CITY OF ALBUQUERQUE

January 7, 2022

RE: 1719 5th St. NW
Grading and Drainage Plan
Engineer's Stamp Date: 11/04/21
Hydrology File: H14D100

BUILDING AND DRAINAGE PLAN

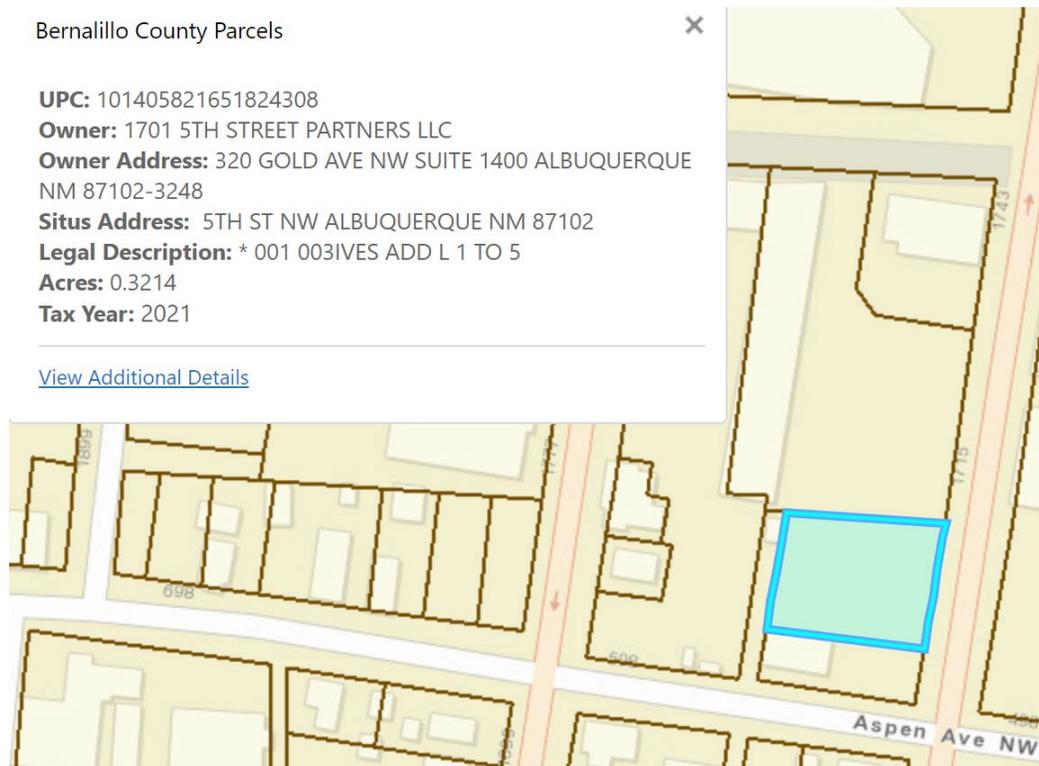
2. It appears that there is proposed grading and construction work being done on a tract of land that is not owned by the project Owner. Provide written and signed permission from the adjoining property owner for work on their property. This should be notarized.

This property is not owned by the Project Owner.

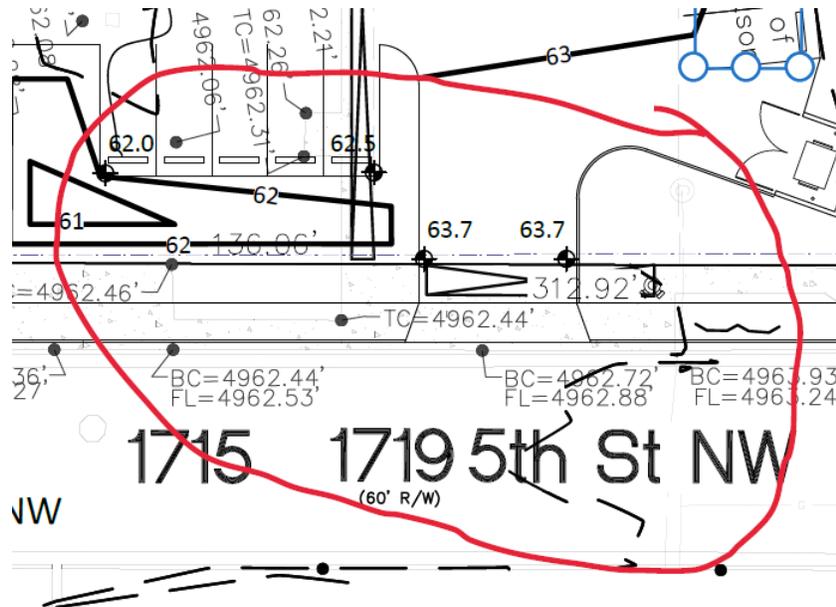
3. Again, it is unclear at what is being constructed within 5th Street R.O.W.

Currently curb & gutter, sidewalk, and two drives on the adjacent property.

At this property's southeast corner of the property line, there is a massive drive for trucks when this existing building was a warehouse. This massive drive extends all the way till right before the railroad spur where there is a curb & gutter. So please indicate on the drawings where the proposed curb & gutter starts and where it ends with existing grades at the existing curb & gutter locations. Also, please replace any traffic signs that are present.

| | DWG. 2426 JUNE 2019 |

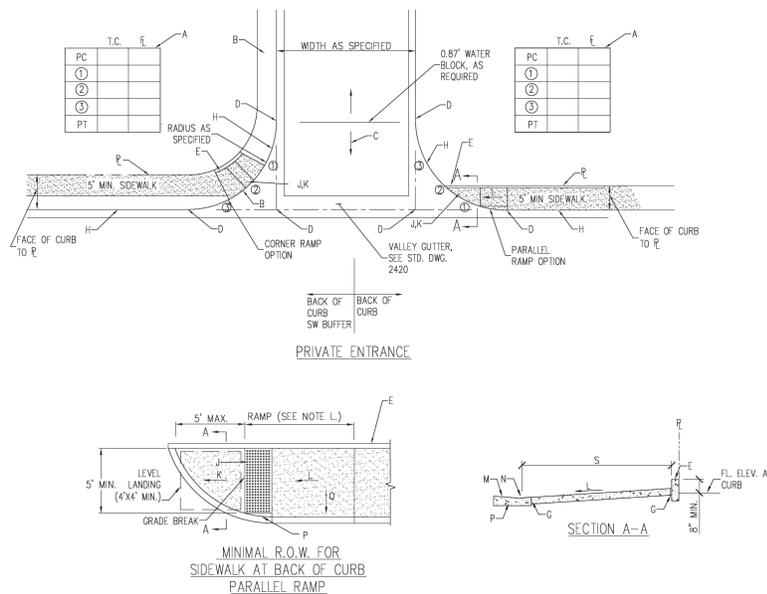
- The entrances proposed on 5th St. do not adhere to the City's private entrance detail #2426. These entrances need to provide curb returns and ADA ramps as shown. This drive is also needed to ensure the water block requirement as shown in the detail.

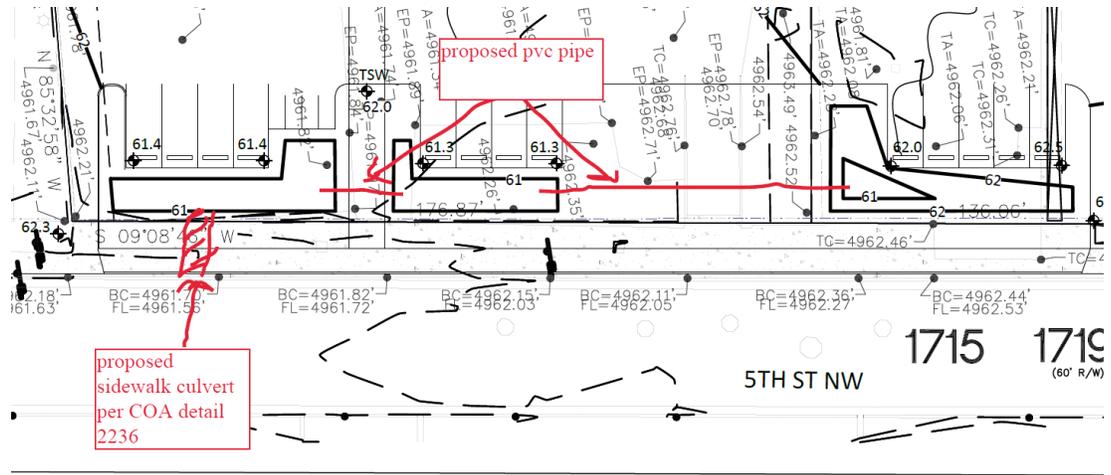
- Please call out the stormwater quality ponds and include the provided SWQV and elevation of the SWQV and the bottom of the pond elevation. Also, please connect the ponds with a pipe so that the spillway required is just one sidewalk culvert.

GRADING AND DRAINAGE PLAN

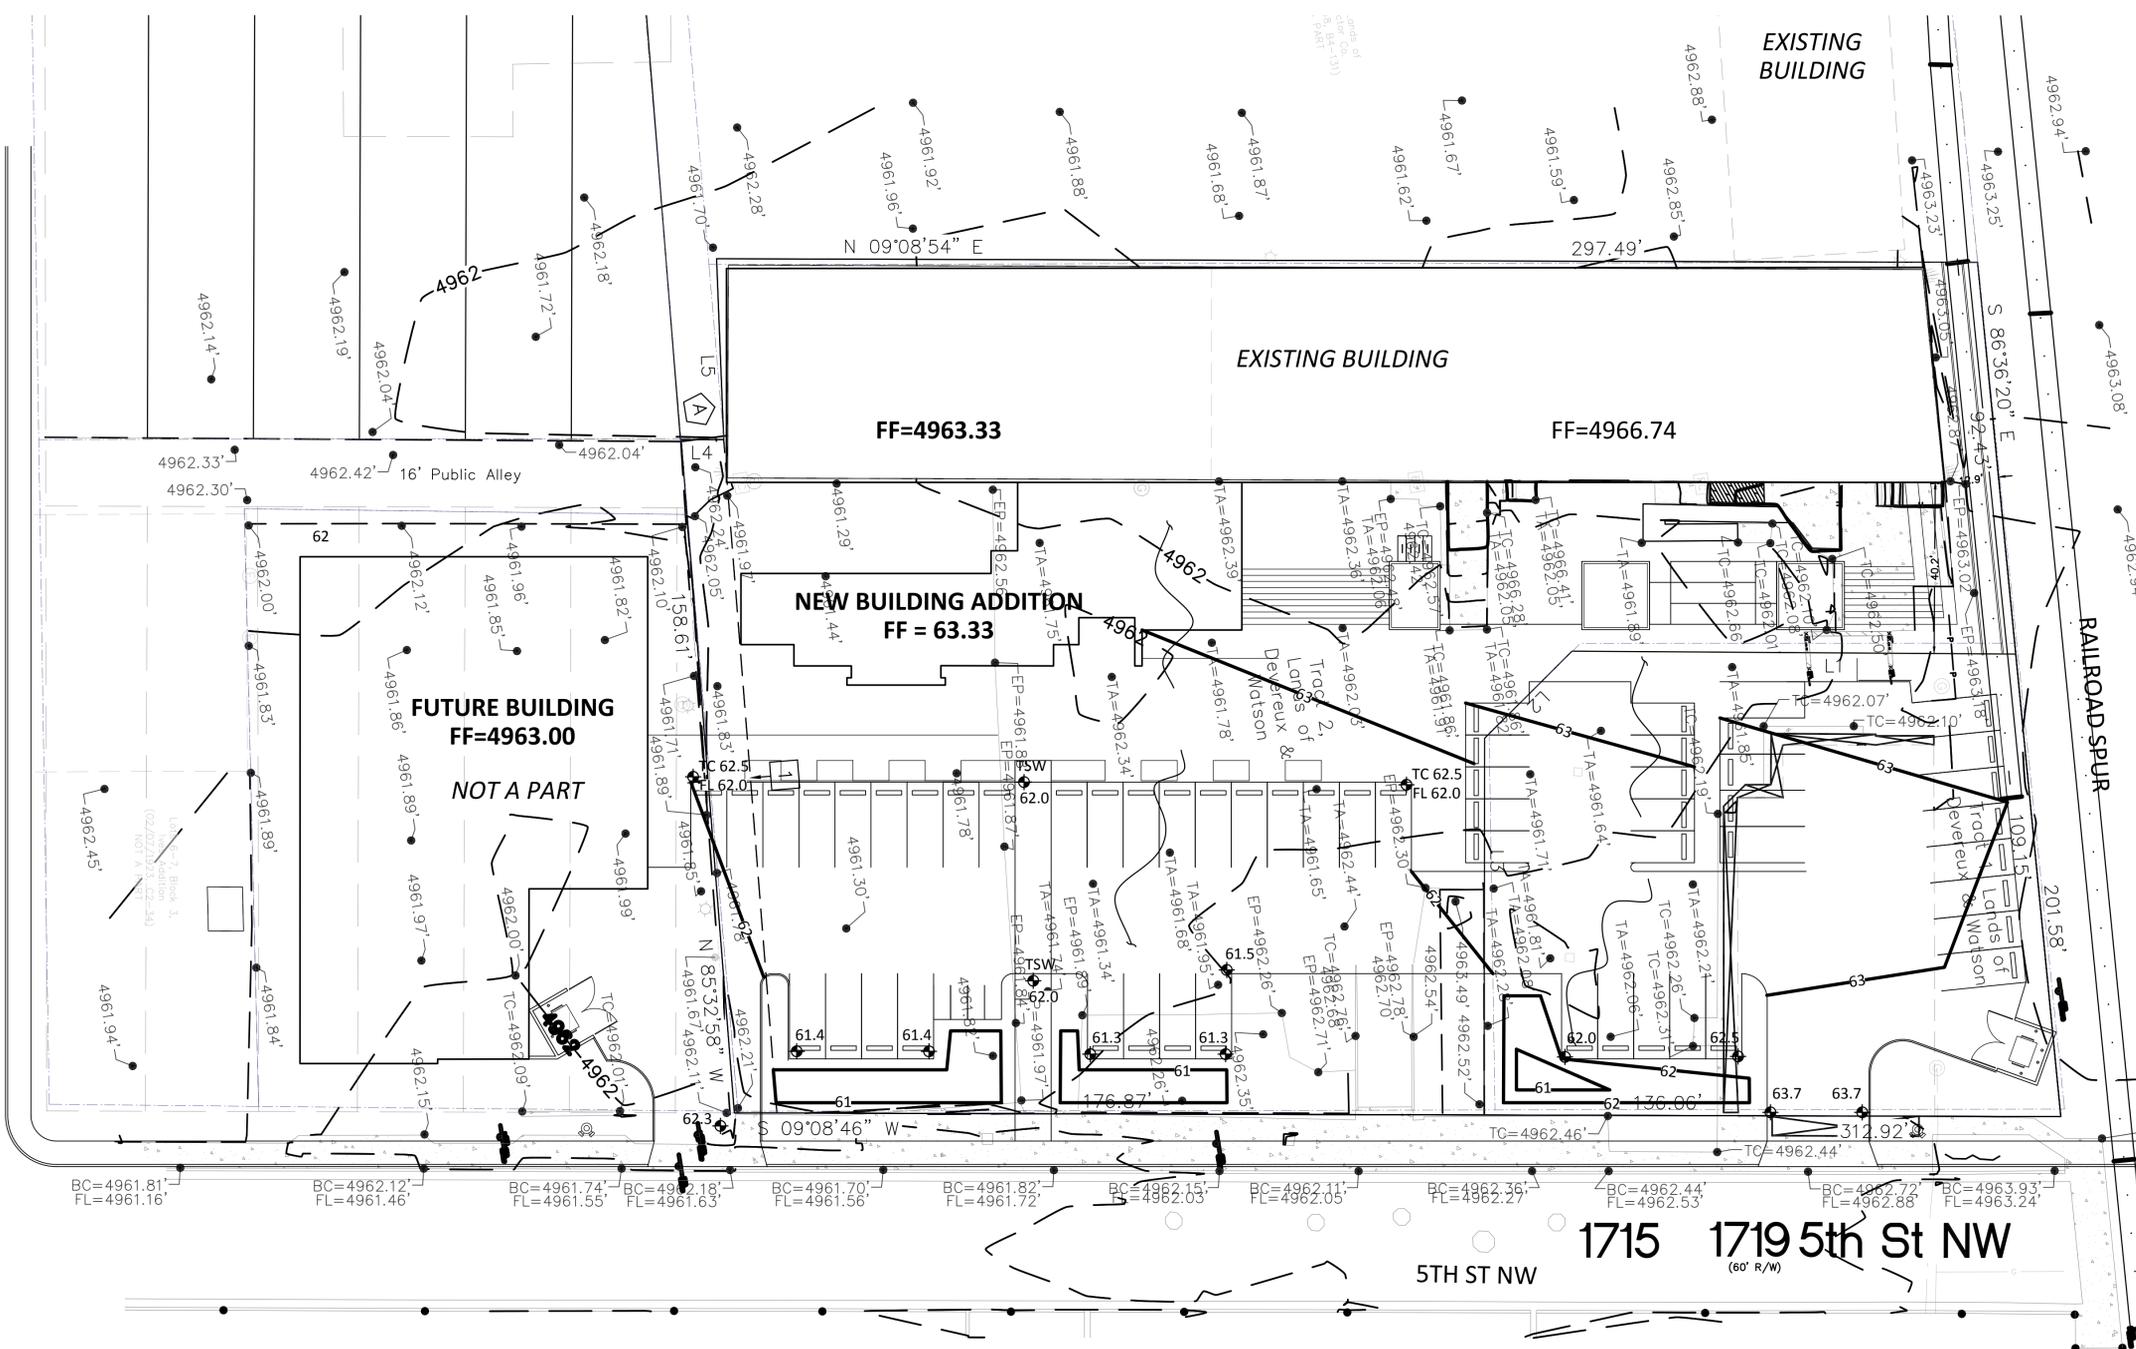
1. It is unclear what is being constructed and what is existing. It is not Hydrology's job to guess and if I can't tell, I know the contractor will not be able to tell as well. In places the line work for the existing is the same line weight as proposed. The only items that stands out are the proposed contour lines. Is the proposed pavement asphalt? At the edge of pavement at places there is a call out of top of curb and at others there is just a spot elevation but the line work is the same at both spots a single line it is not clear where the proposed curbing onsite starts and where it stops. The standard for a curb is a double line. Please clean this up.

6. Please reference City of Albuquerque standard detail No. 2236 – Sidewalk Culvert with Steel Plate Top at the sidewalk culvert. Also, please provide the invert elevation inside the SWQ pond (this should be equal to the SWQV elevation) and the invert at the gutter.
7. Please provide the weir calculations, per DPM Article 6-16(A), for the sidewalk culverts. A coefficient of 2.7 is typically used for the weir equation $Q = CLH^{2/3}$.
8. For trash enclosures serving food service developments, demonstrate control of liquids from dumpster areas per DPM by: containing runoff from the dumpster area, preventing outside drainage from entering the dumpster area, and discharging to the sanitary sewer. Please show the inlet and state, “Drain to proposed sanitary sewer. See Utility Plans”.
